## TECHNICAL SERVICE BULLETIN

SUBJECT: PARKING BRAKE CABLE CLIP  
RETENTION - 1963 CORVETTE

BULLETIN NO. DR #608

DATE June 29, 1963

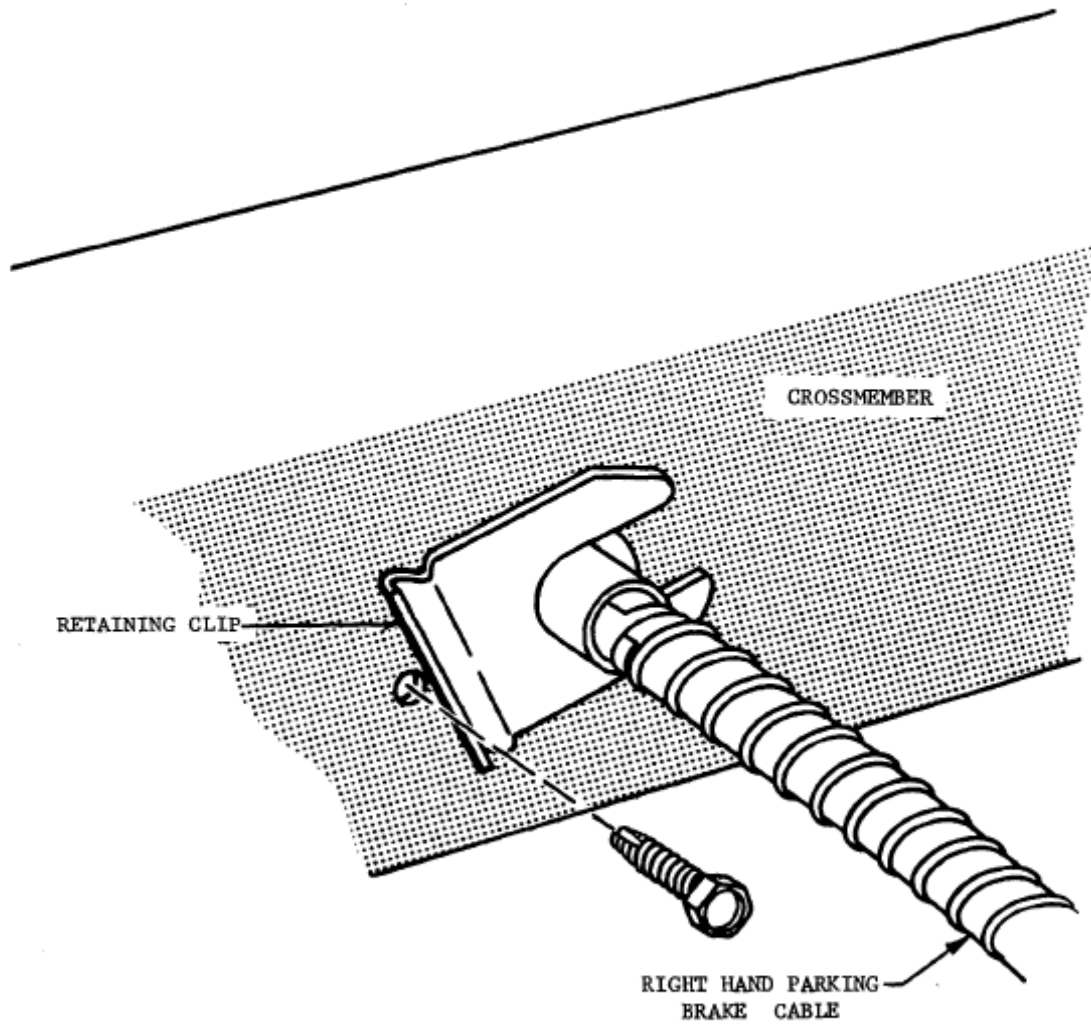
The 1963 Corvette right hand parking brake cable housing is retained to the frame crossmember at the forward end by a U-shaped clip (see 1963 Corvette Shop Manual, page 5-3, fig. 5). During application of the parking brake, movement of the cable housing may allow this U-shaped clip to work loose. Loss of retention will permit the cable to pass through the crossmember resulting in continuous brake drag and subsequent failure.

To prevent this retainer clip from working loose, drill a 7/32" hole and install a 1/4" x 20 self-tapping screw, Part No. 9411890, as illustrated.

ROTATE CLIP TO POSITION SHOWN  
DRILL 7/32" HOLE AND INSTALL  
1/4 x 20 SCREW TIGHT AGAINST  
CLIP
